P.O.A.D.P. PLAN  
 for  
 EISENHAUER ROAD 21.8

**CITY OF SAN ANTONIO  
POADP APPLICATION**

Re: Eisenhower Road 21.8

POADP # 639

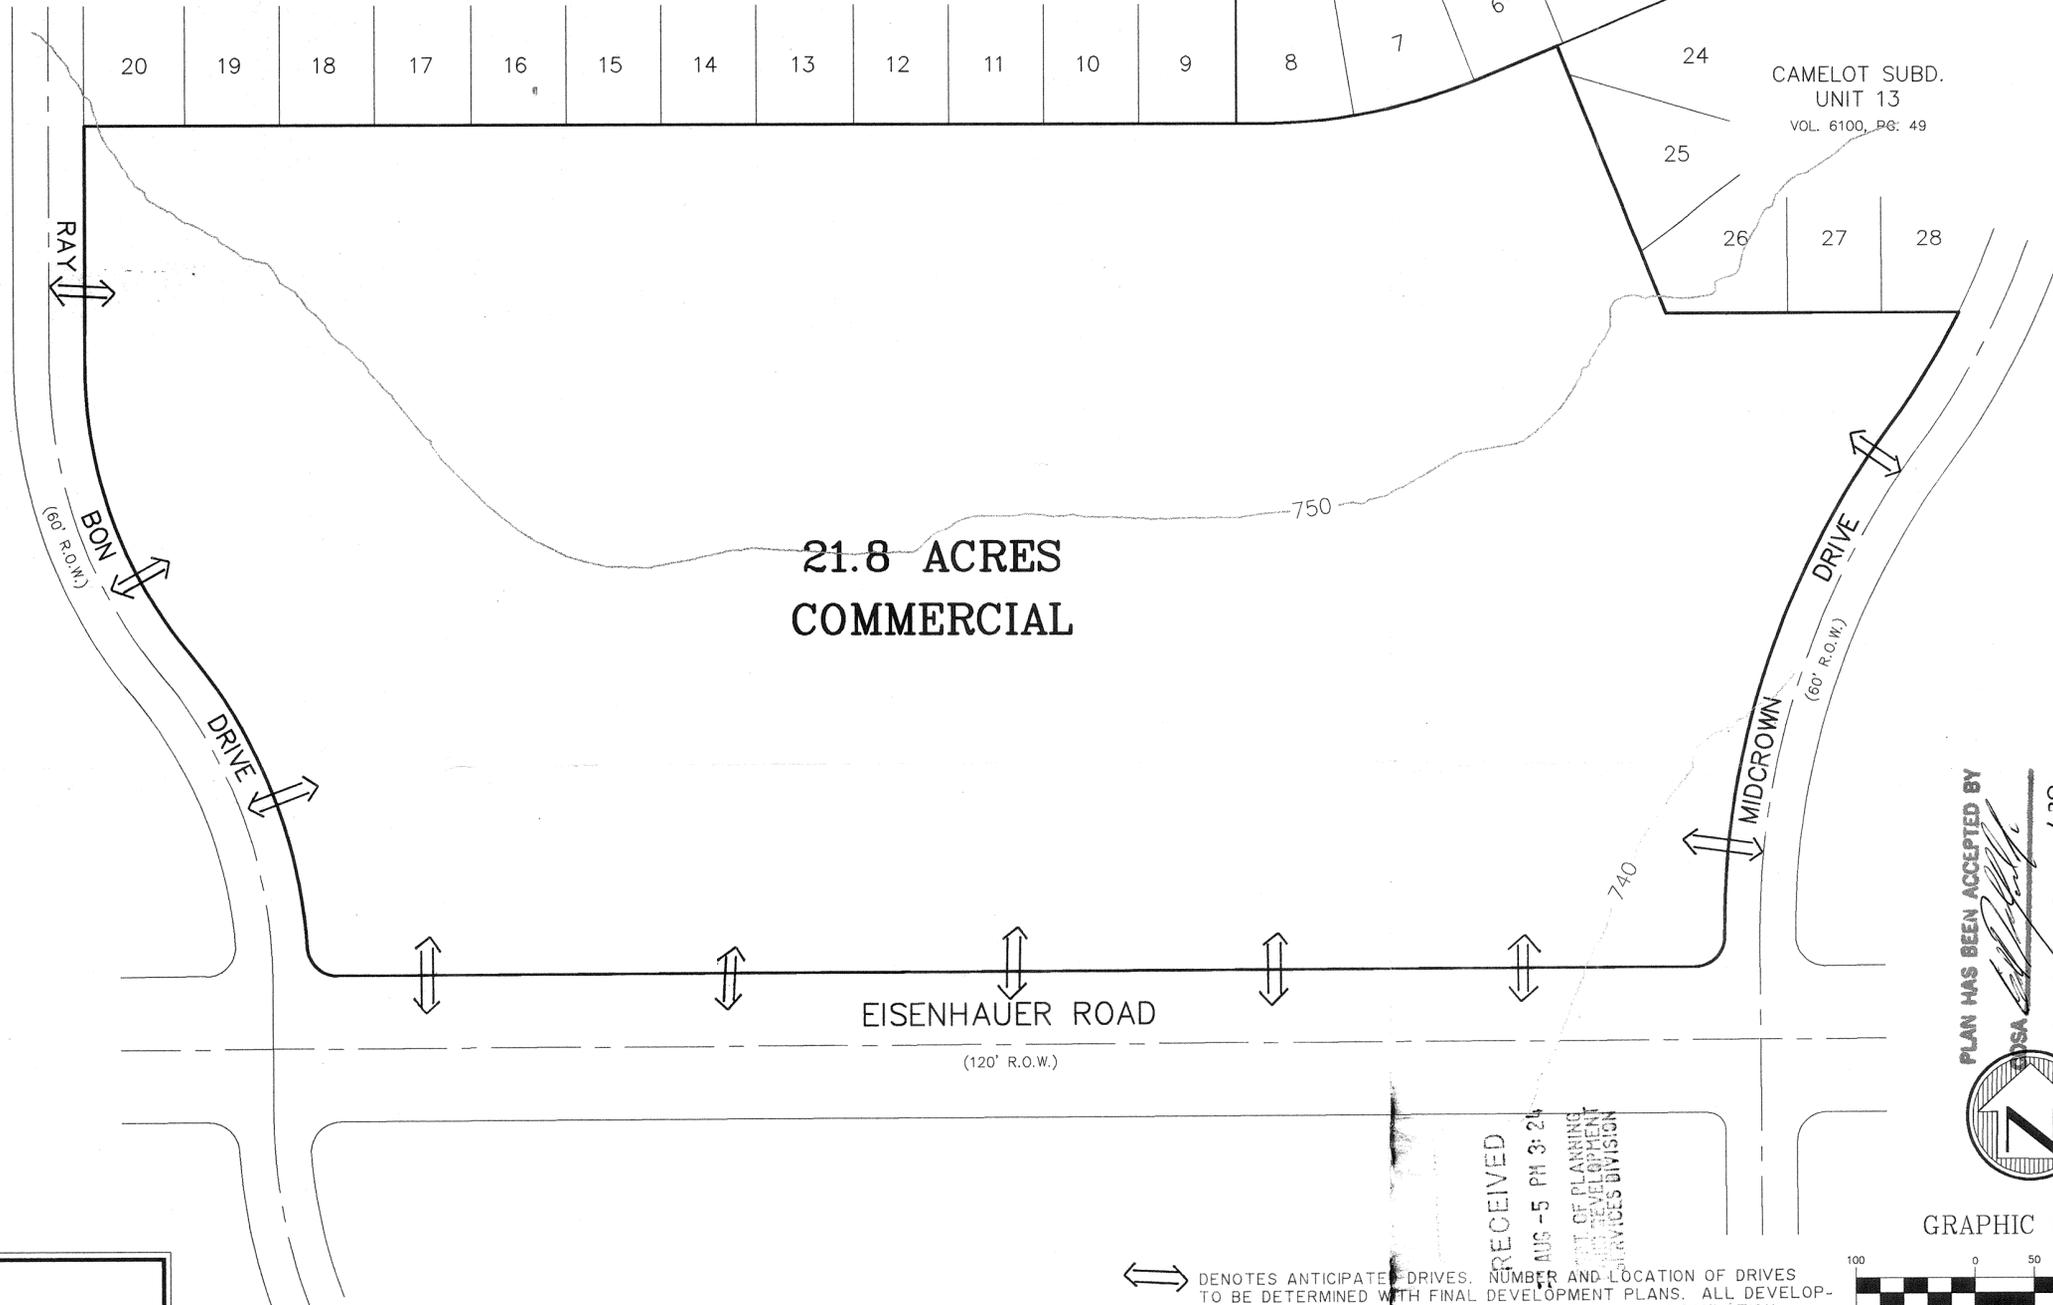
The City Staff Development Review Committee has reviewed Eisenhower Road 21.8 Subdivision Preliminary Overall Area Development Plan # 639. Please find enclosed a signed copy for your files. Although your plan was accepted, please note the following:

- Based on the topography, a Flood Plain Study and drainage review will probably be required during the platting process.
- In consideration of public safety and convenience, excessive grades by reason of topography should be avoided in street layouts and arrangements.
- Access along Eisenhower Road, Midcrown Drive and Ray Bon Drive will be limited to two driveways each, with the understanding that the development would include shared access and internal circulation.
- This development will need to comply with tree preservation ordinance #85262. For information about these requirements you can contact Building Inspections at 207-7102.
- It will be expected that you will plat all of the property depicted in your POADP, to include: floodpains, drainage areas and open space.
- I would encourage you to work closely with the school district, so that they can plan accordingly.
